V ASHWAUBENON, CORMIER RD
ONEIDA ST - ASHLAND AVE
CORMIER ROAD
BROWN COUNTY

STATE PROJECT NUMBER
9266-11-01

PROJECT NO: 9266-11-01	HWY: CORMIER ROAD	COUNTY: BROWN	STORM SEWER	SHEET	E
------------------------	-------------------	---------------	-------------	-------	----------

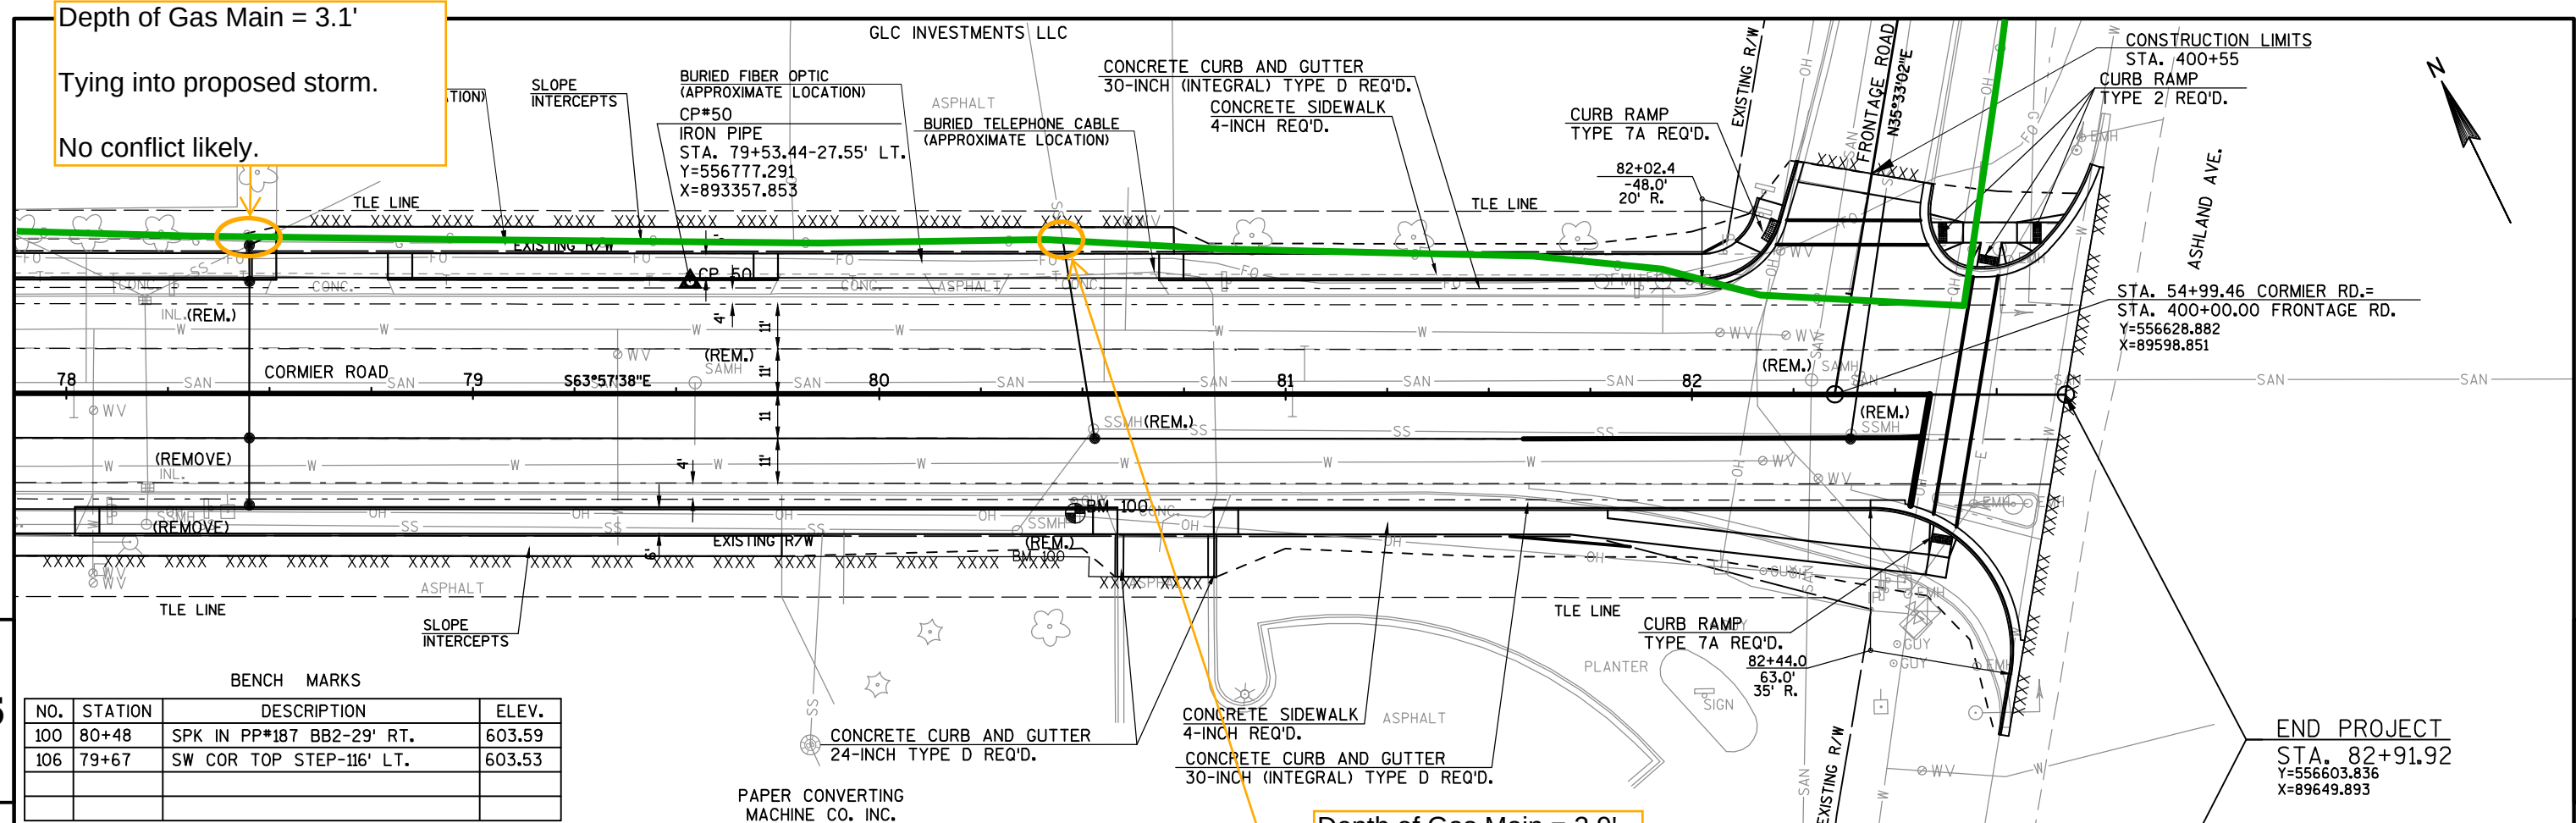
No conflict likely.

Depth of Gas Main = 2.9'

Tying in proposed storm to
ex. storm sewer.

No conflict likely.
